Vertical Section

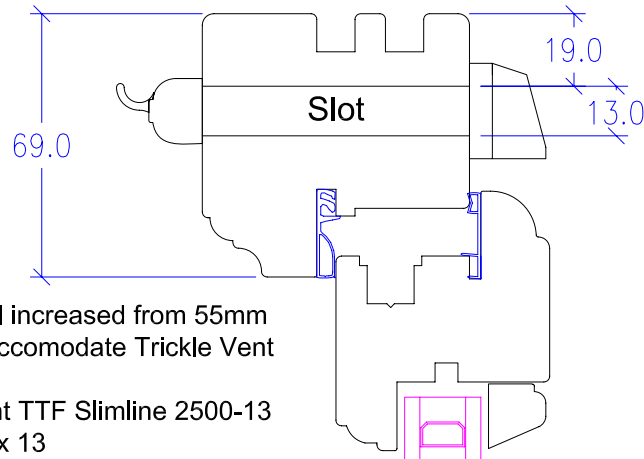
Frame top rail increased from 55mm to 69mm to accommodate Trickle Vent

Standard Vent TTF Slimline 2500-13 slot size 265 x 13

If Frame is under 350mm in width use TTF Slimline 1250-13, Slot size 133 x 13
